Project: 08-25-3320 HCA LSMC DIETARY EXPANSION
2100 SE BLUE PARKWAY
LEE'S SUMMIT, Missouri 64063

RFI #049: Canopy Concrete Pedestal Dimension and Cladding

SECTION AT CANOPY COLUMN

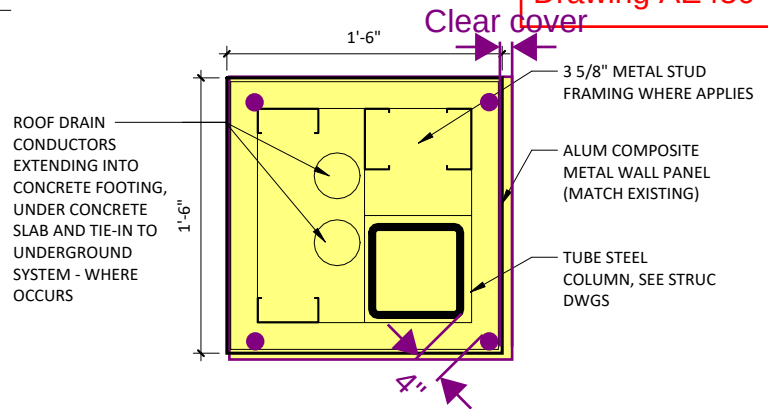
Drawing S201, Detail 12 show the concrete pedestal, on detail 9 it shows 1' - 3" please provide clarification on concrete pedestals dimension. We checked AE450 (Details 8 and 9) and we could see that the pedestal will get aluminum composite metal wall paneling that will be 1'-6" x 1'-6", but we did not see the dimensions for the concrete pedestal. Please advise.

Can you tell us this dimension?

REFER TO THE MARKUPS AND THE COMMENTS ON THE LAST SHEET.

CANOPY COLUMN

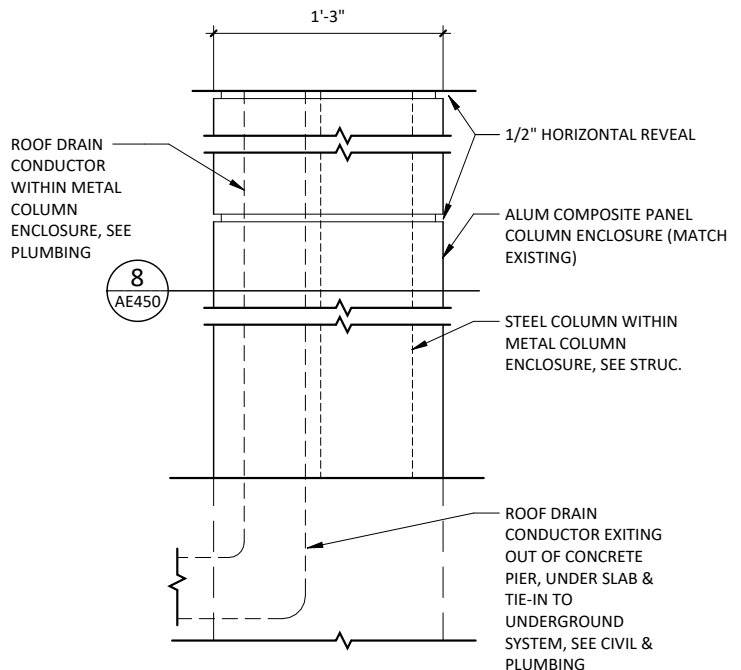
Can you also confirm that the aluminum composite metal wall paneling will be installed instead of the EIFS called out in S201?

THE ARCHITECT TO CONFIRM THE DIMENSION OF THE PEDESTAL REQUIRED UNDERNEATH THE METAL STUD FRAMING. PROVIDE 4#5 BARS IN THE PEDESTAL PER DETAIL 12/S201. THE CLEARANCE BETWEEN THE STEEL COLUMN AND BAR SHOULD BE AT LEAST 4". PROVIDE THE EXTERIOR CLEAR COVER PER S011.
